PLANNING BOARD AGENDA FOR JANUARY 13, 2026 - 7:00 PM

1. **Salem NIM, LLC Site Plan** – Public Hearing for change of use for 19,960 sq. ft. restaurant and entertainment use with conditional use permit for reduced parking and additional signage at 11 Mall Road, Map 107, Lot 11154. Continued from 12/9/2025.

Below please find our responses comments discussed in our December 9, 2025 meeting and at the PB meeting. Below please find each comment followed by our response in **bold**.

Site Development Plan For:
LYONS GROUP RESTAURANT
AT THE MALL AT ROCKINGHAM PARK
11 MALL ROAD
SALEM, NH

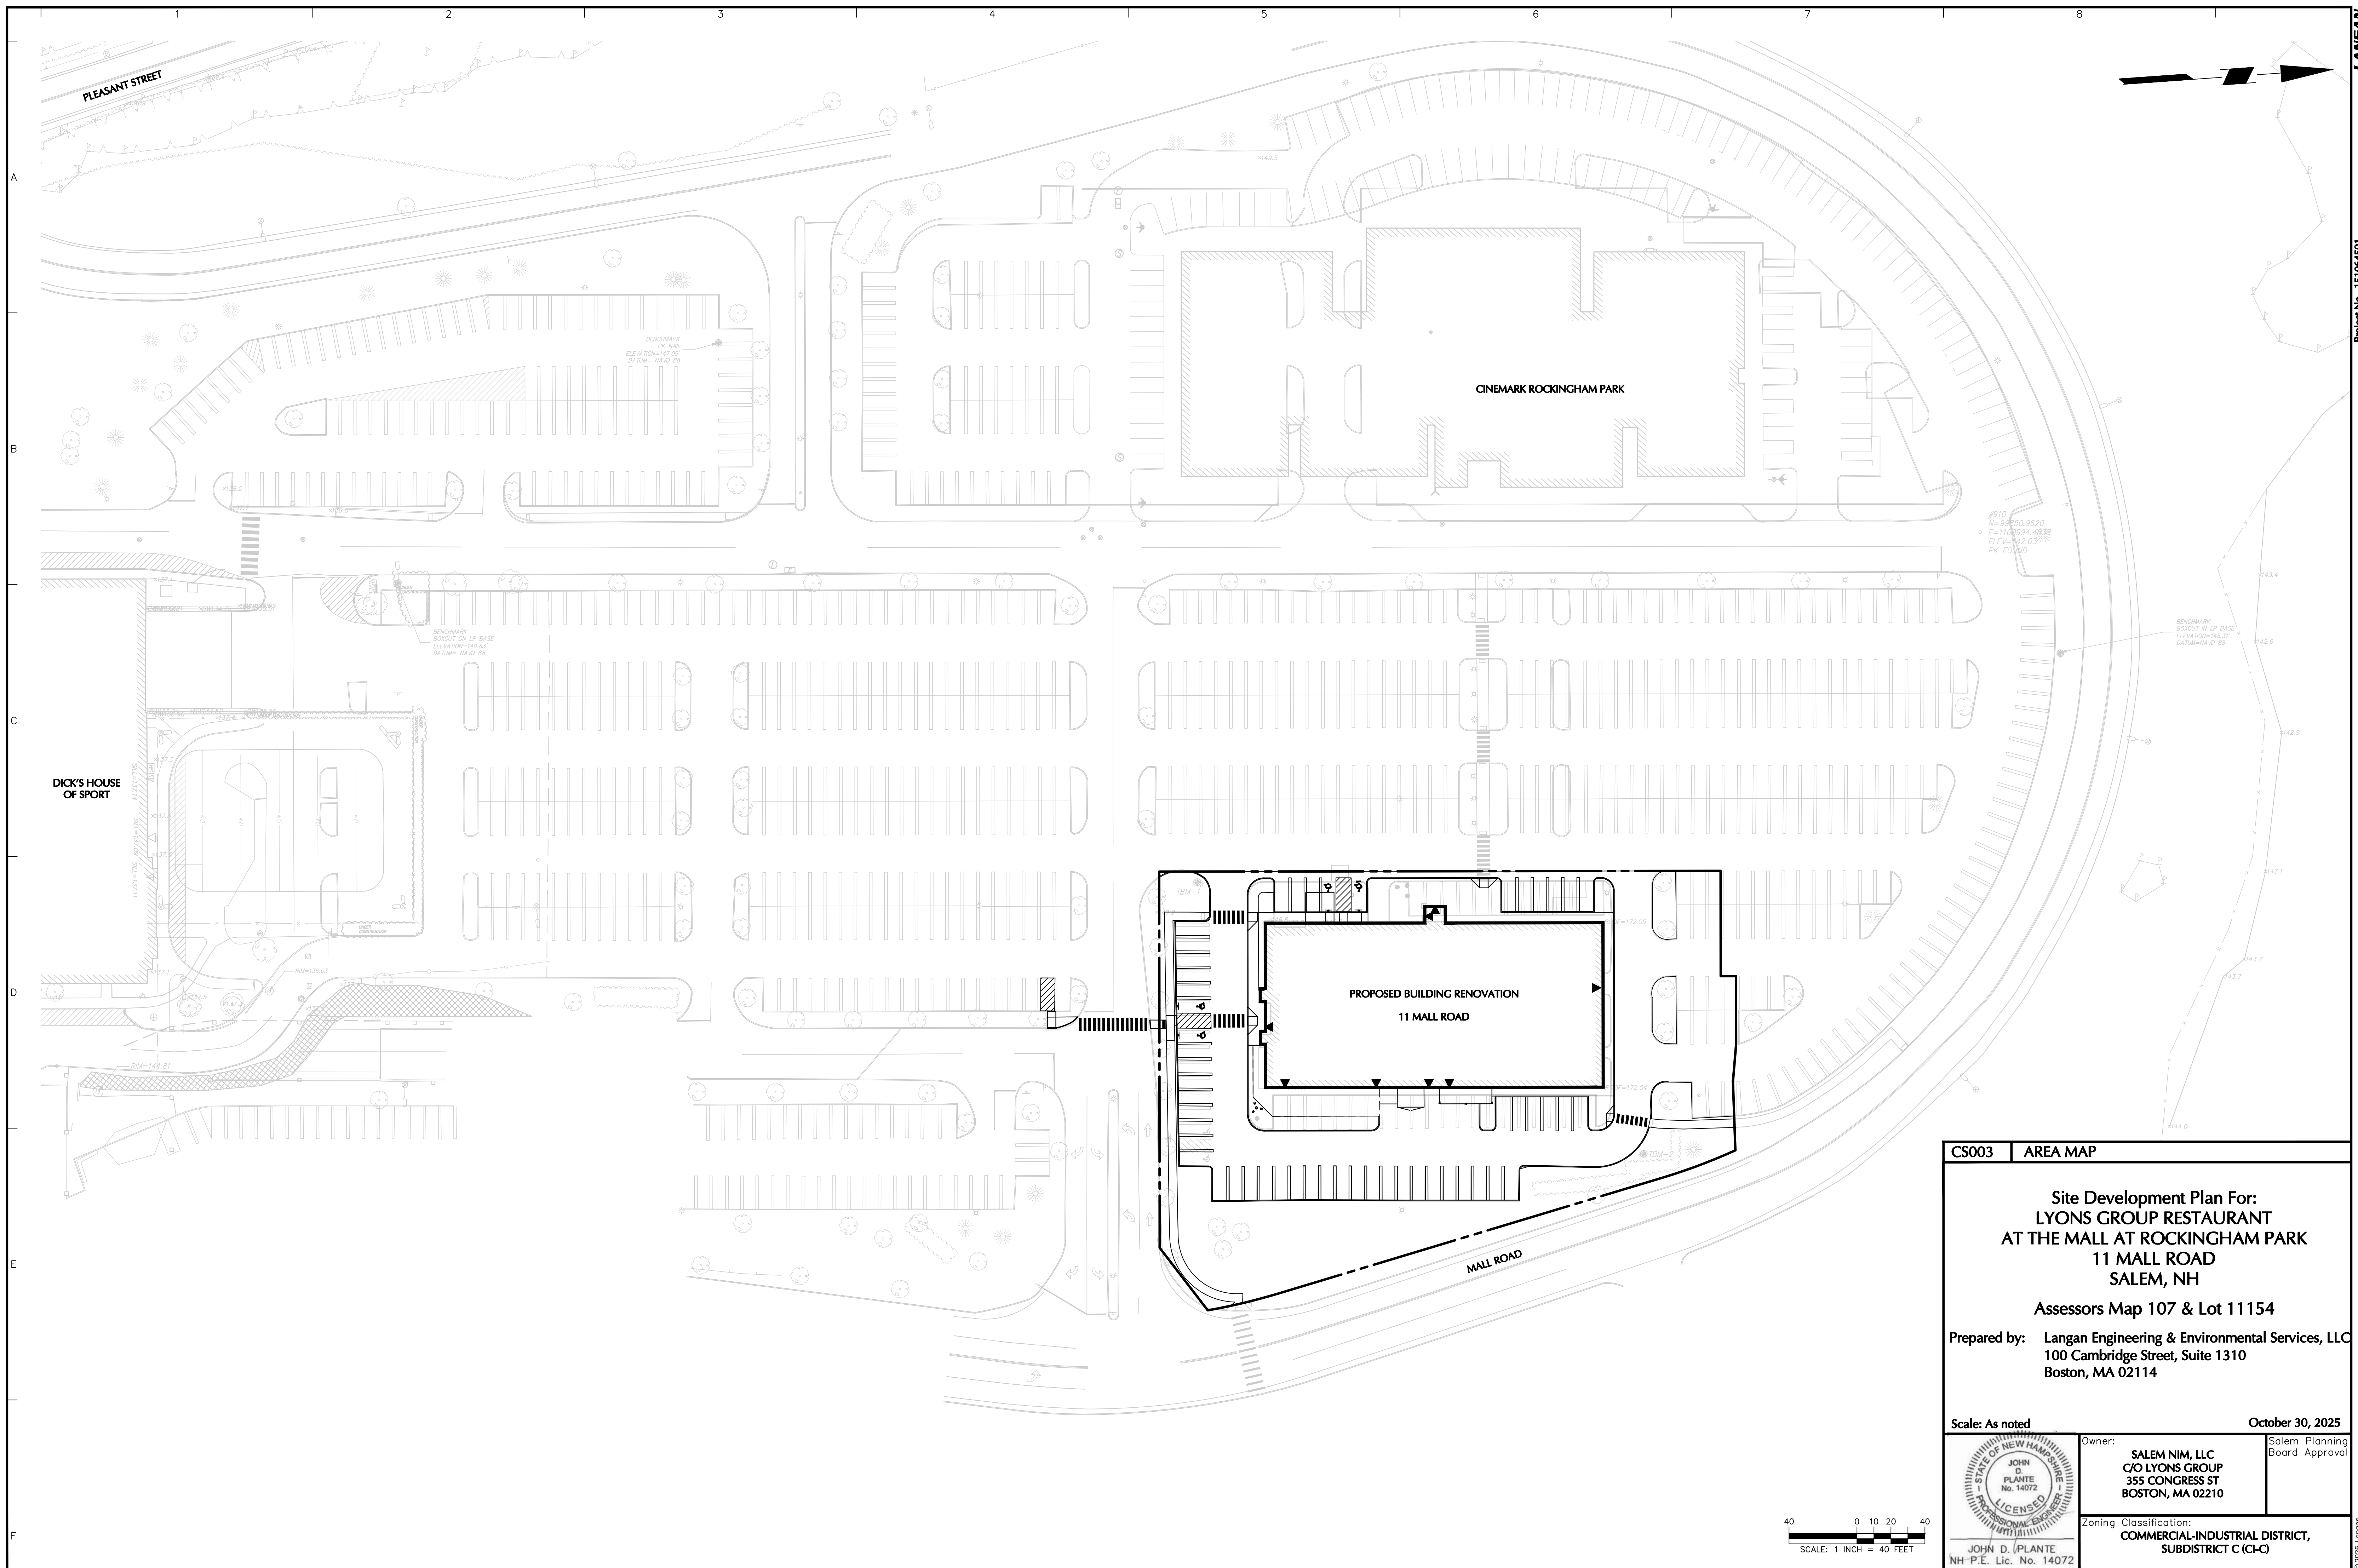
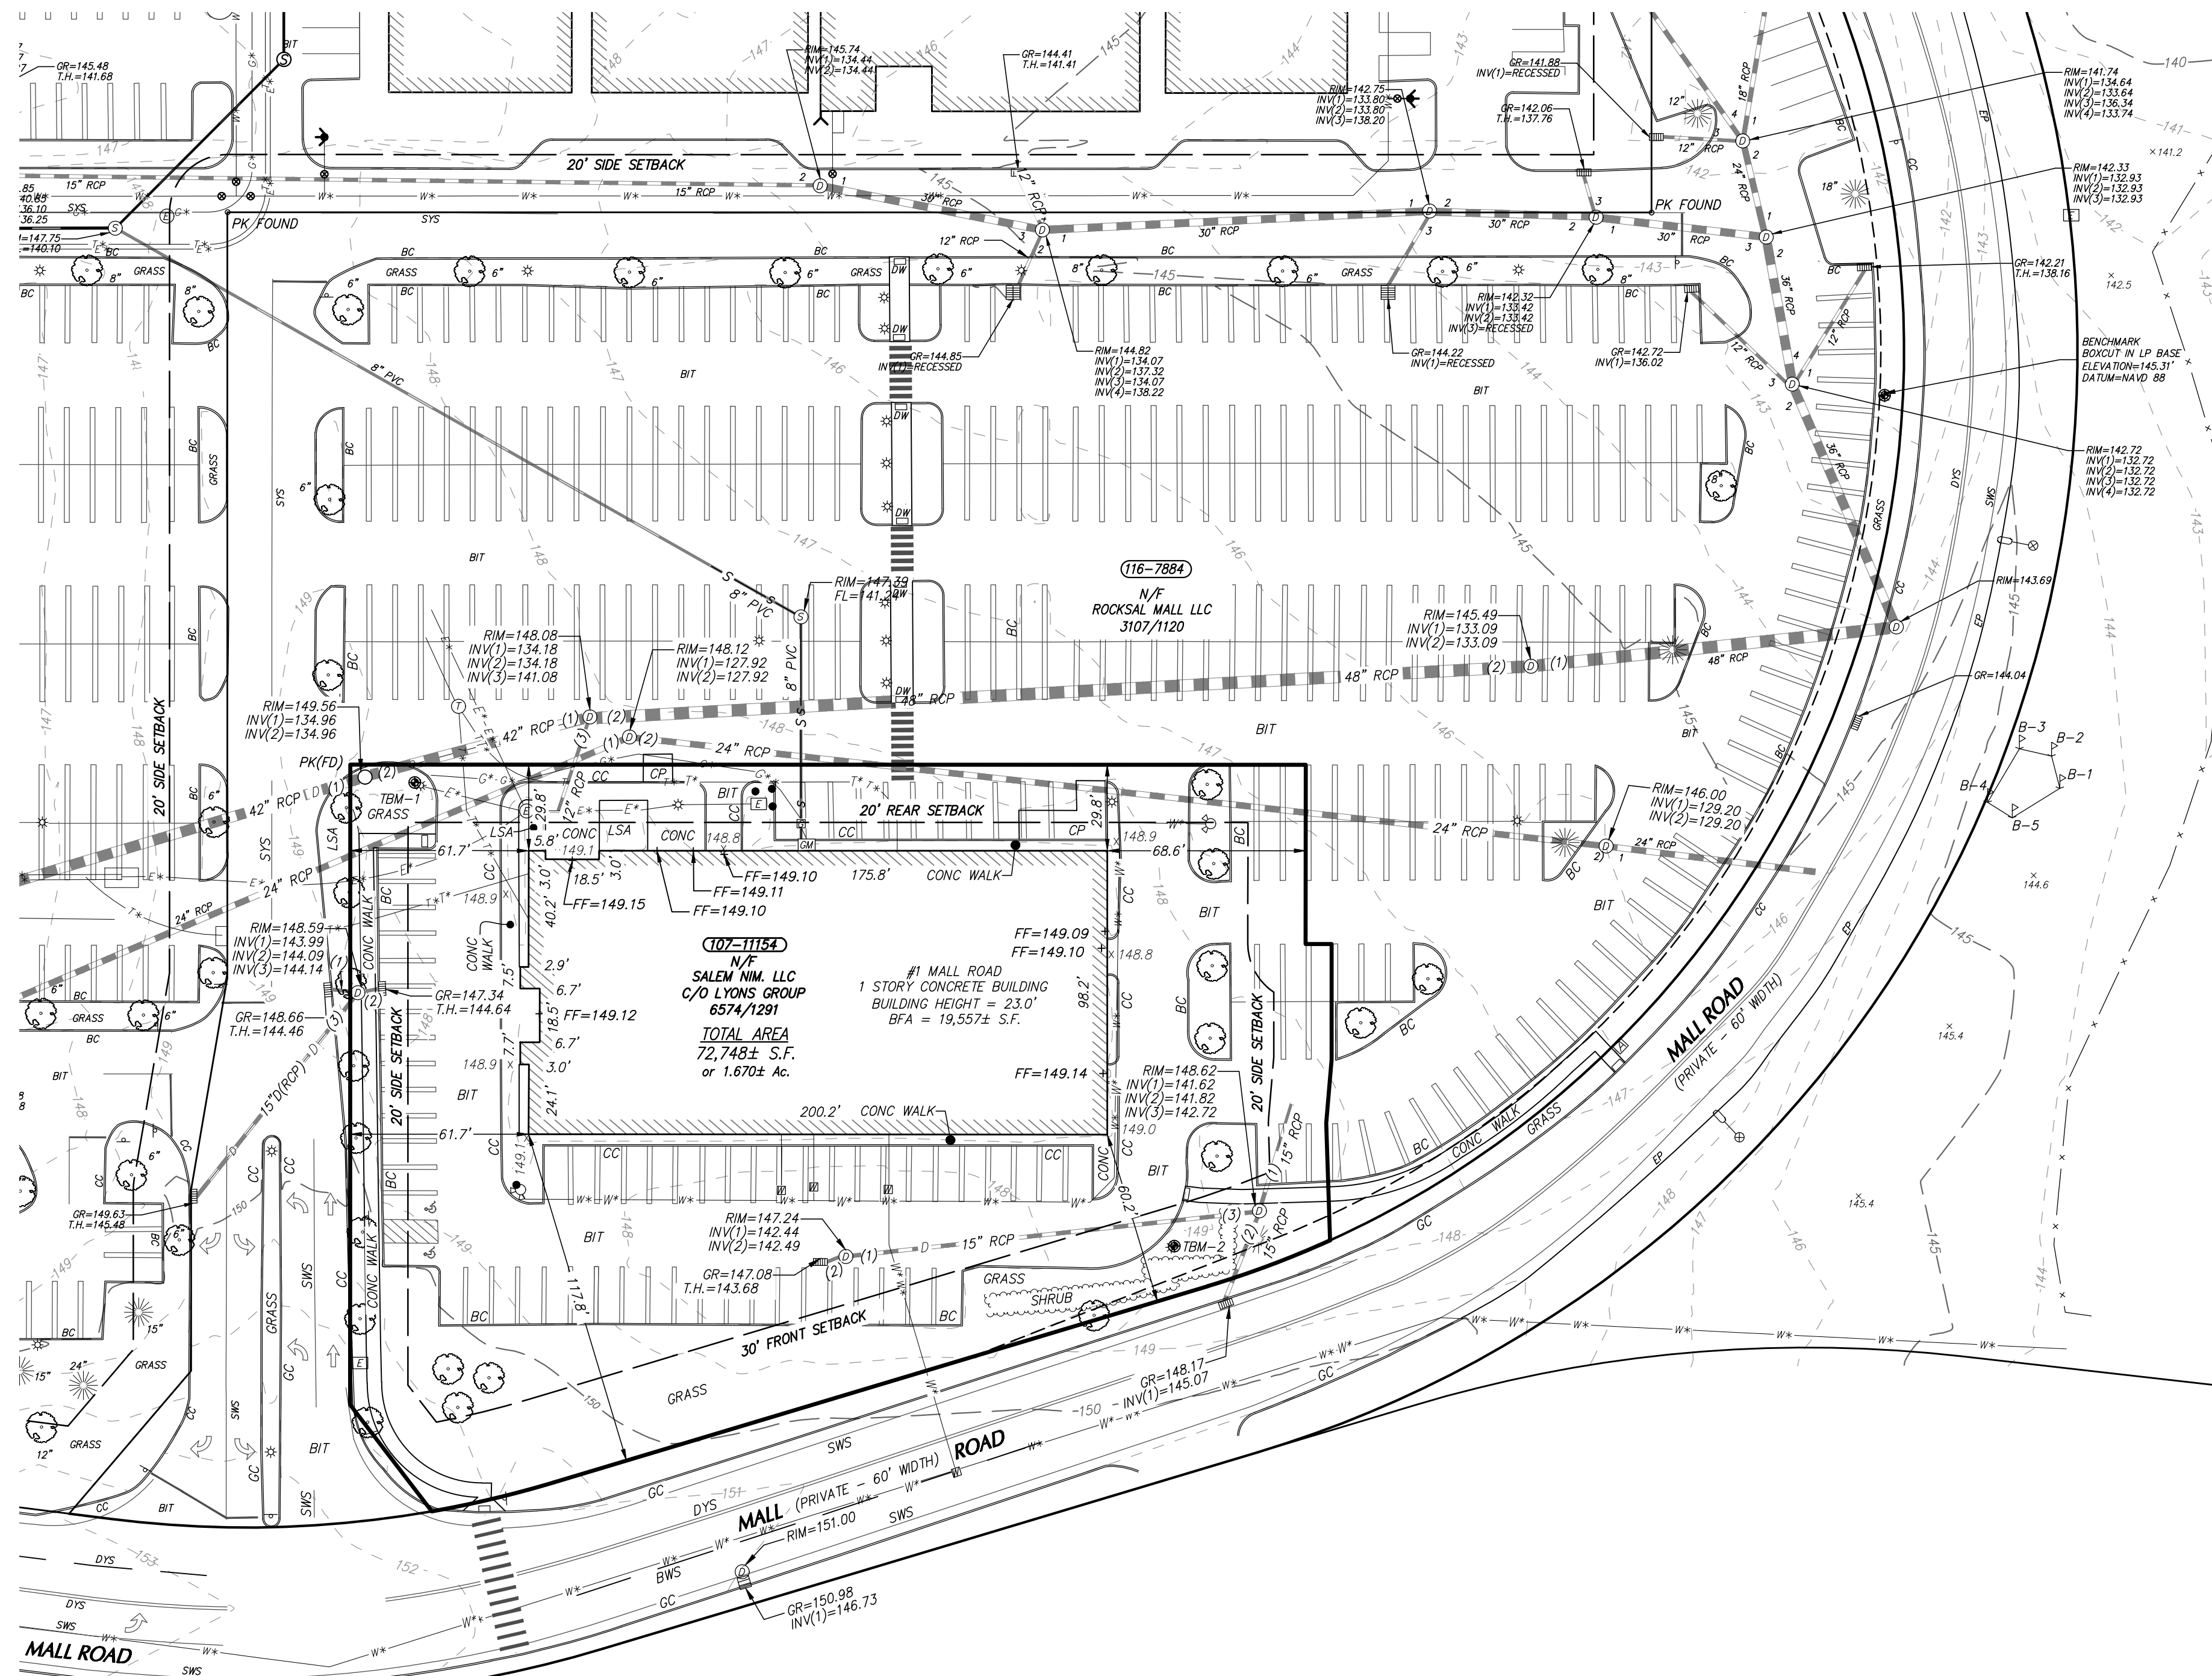
- Eliminate zoning table on Existing Conditions Plan

COMMENT RESPONSE: Zoning Table has been removed from VT901.

CS101 EXTERIOR SITE PLAN

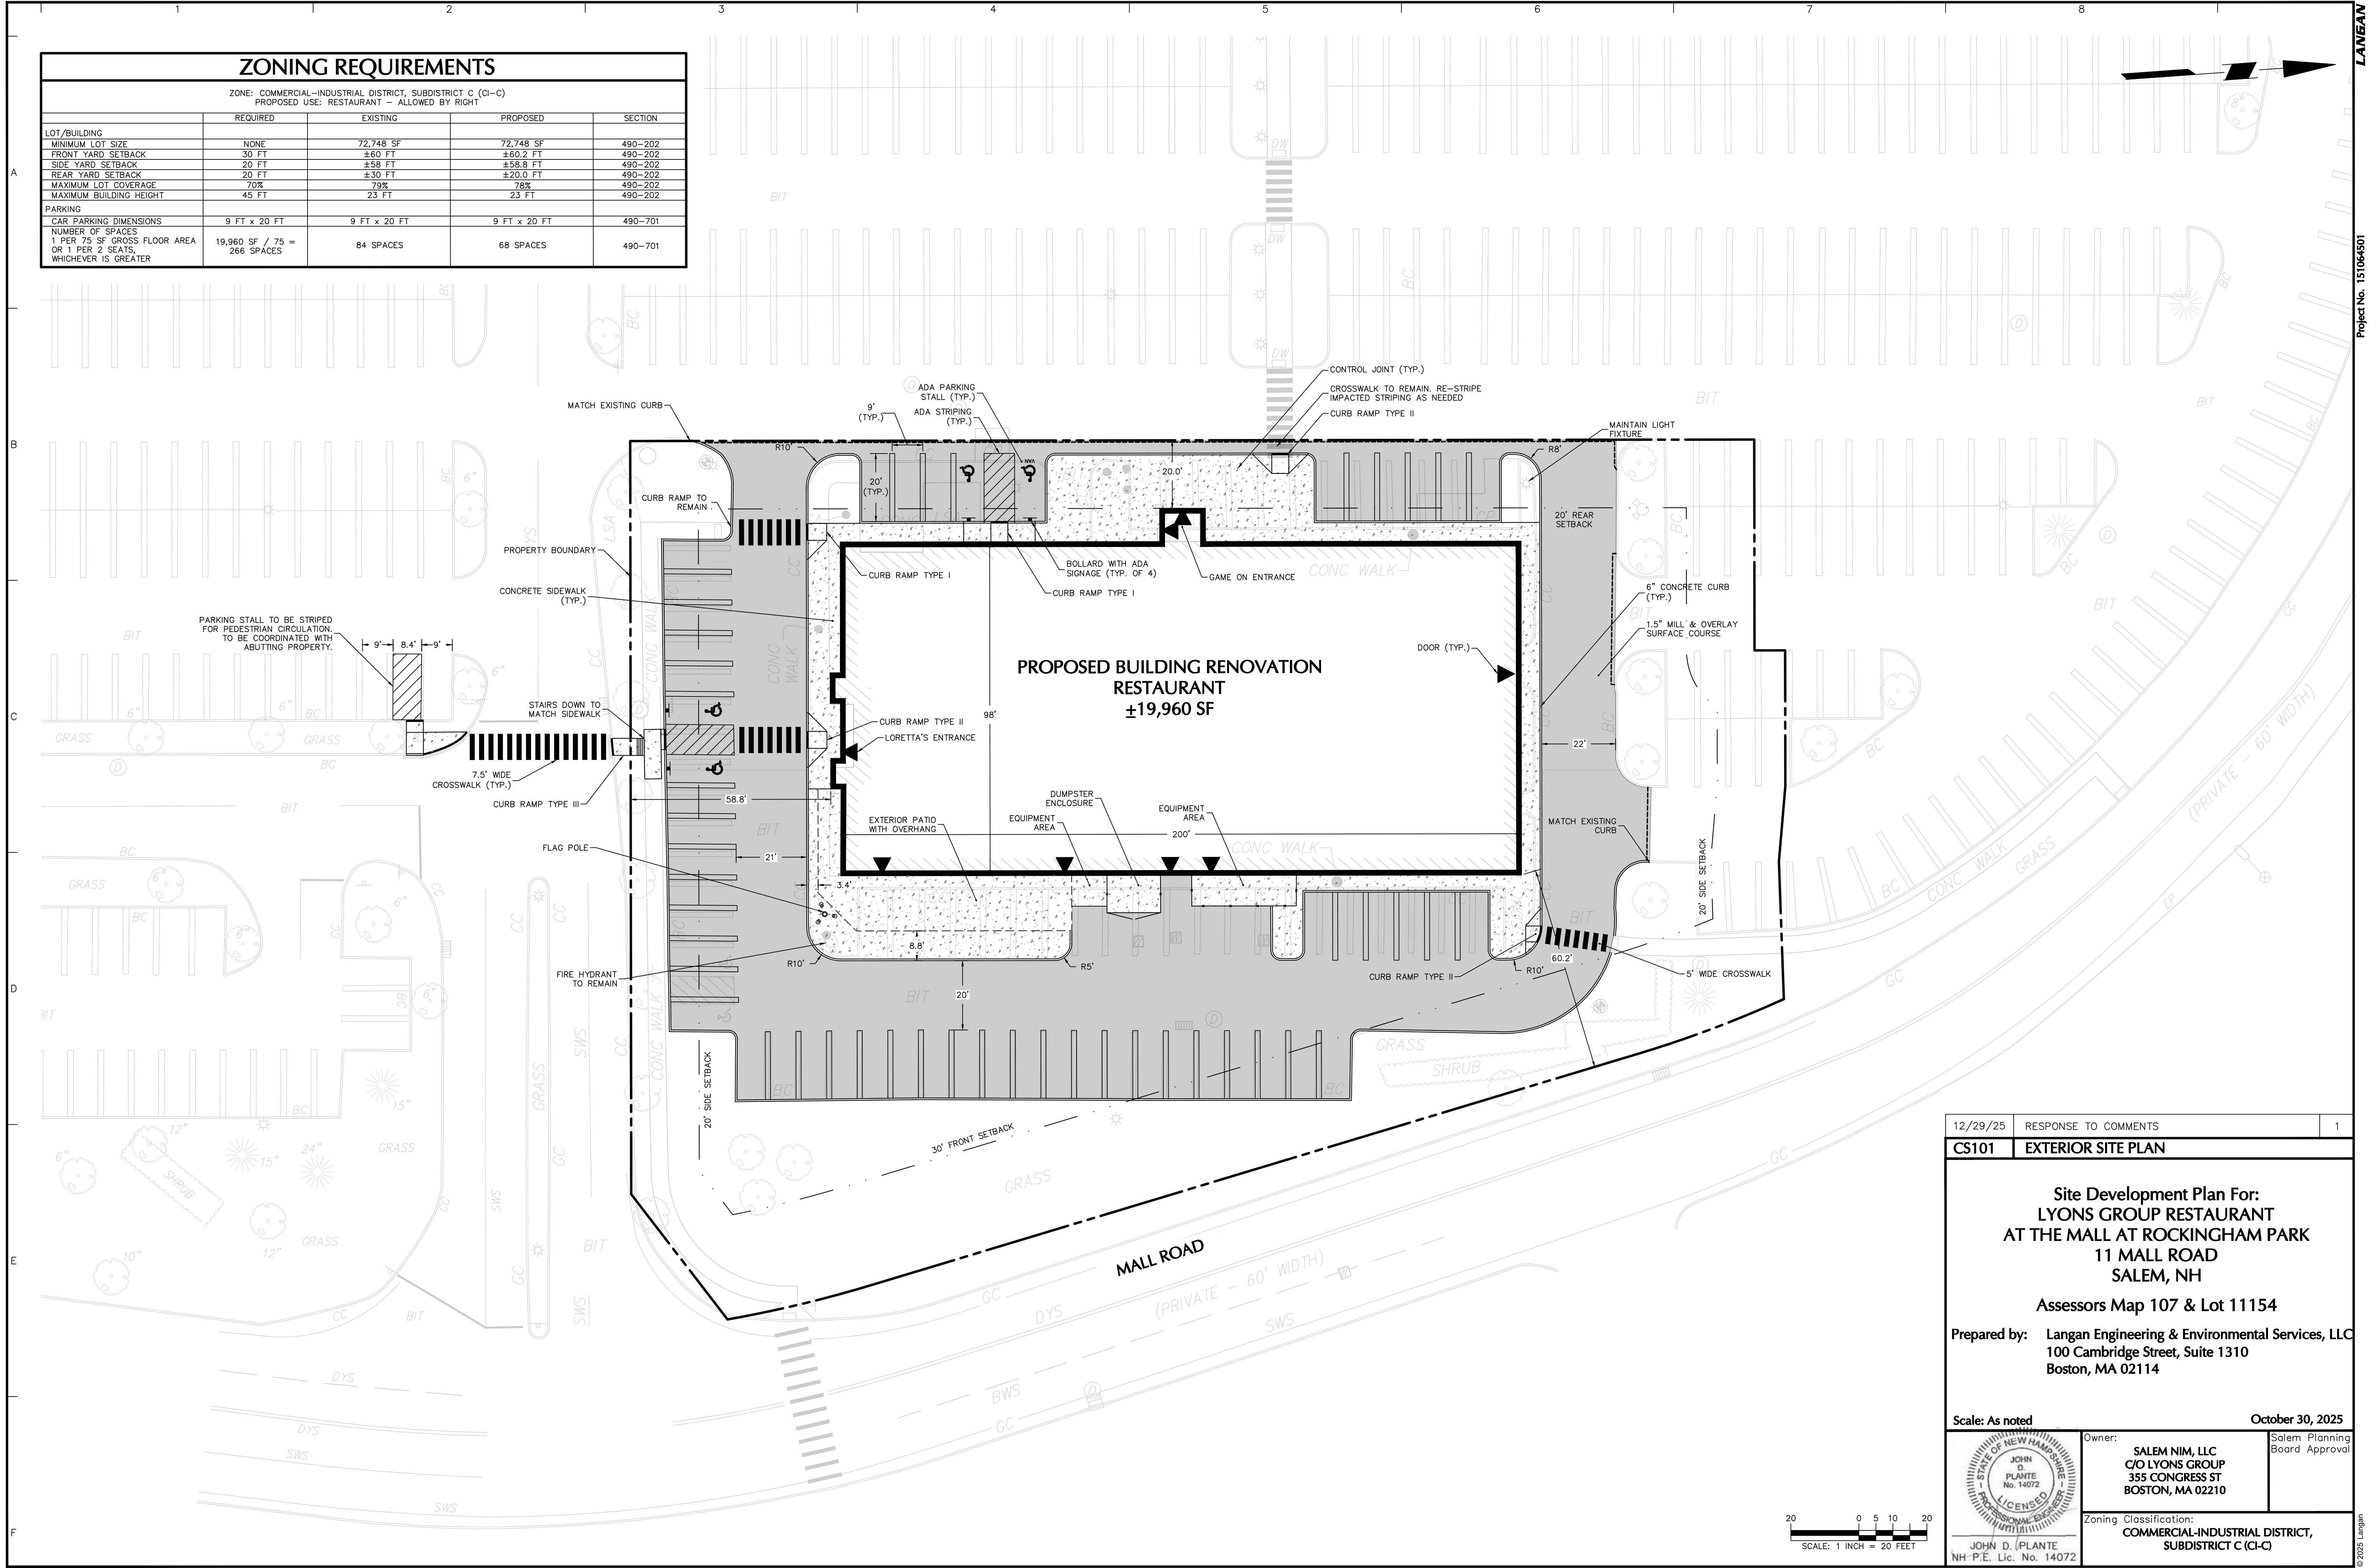
- Add pedestrian connection to north sidewalk

- Add tip down at ADA spaces to ped. connection to south

- Add dimension of striped space to south

COMMENT RESPONSE: Curb ramp with crosswalk has been added to the plans. Please see CS101.

COMMENT RESPONSE: Tip down to ADA spaces has been added to south sidewalk connection, as seen on CS101.

COMMENT RESPONSE: Dimensions have been added to restriped southern parking area, seen on CS101.
